ROADSTER WARRANTY Bulletin

Campaign no.: 2011-0016
2012-0006

No. **2012-8**

- 1- Updated Throttle Body Actuator Protection**
- 2- ECM and TCM Software Updates**
- 3- Middle Side Panel Grommet Replacement (2011 Models Only)**

OLD TYPE - SMOOTH OUTER EDGE

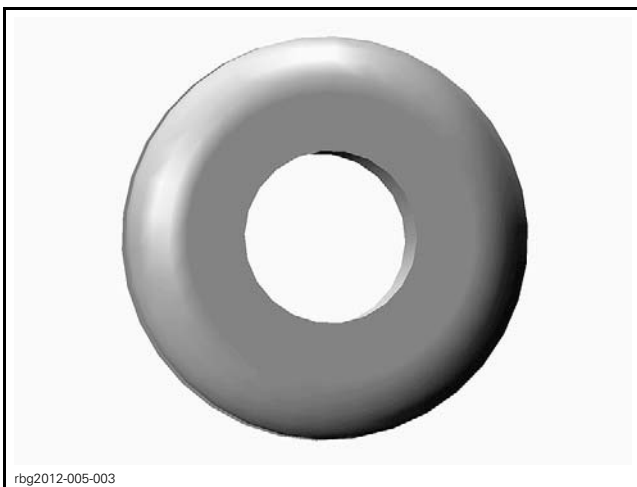
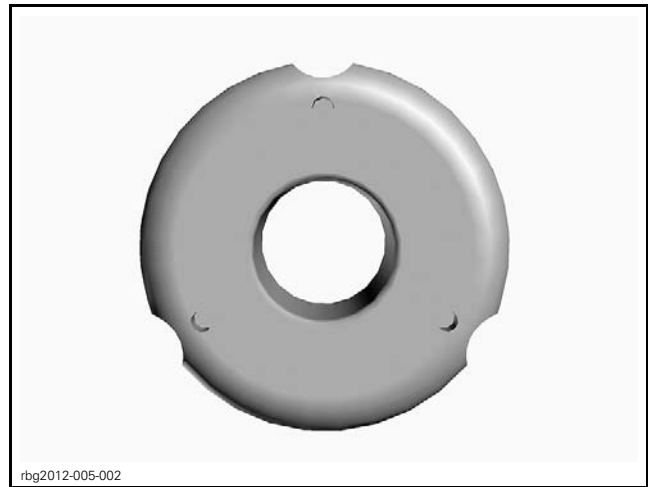
On some 2011 vehicles, on which *2011-8 OR 2011-13 WARRANTY CAMPAIGNS* has not been performed, one of the middle side panels rubber grommets might fall off after multiple removal and installation of the panel.

Install a NEW improved grommet if applicable.

GROMMET TYPE	ACTION
Old Grommet type	Replace by (P/N 705 003 264)
New Grommet type	No action required

3. If required, remove the grommet using a flat screwdriver.
4. Scrape off any remaining grommet and glue residue from area where grommet was glued.
5. Install the new grommet.
6. Repeat steps on the other side of the vehicle.
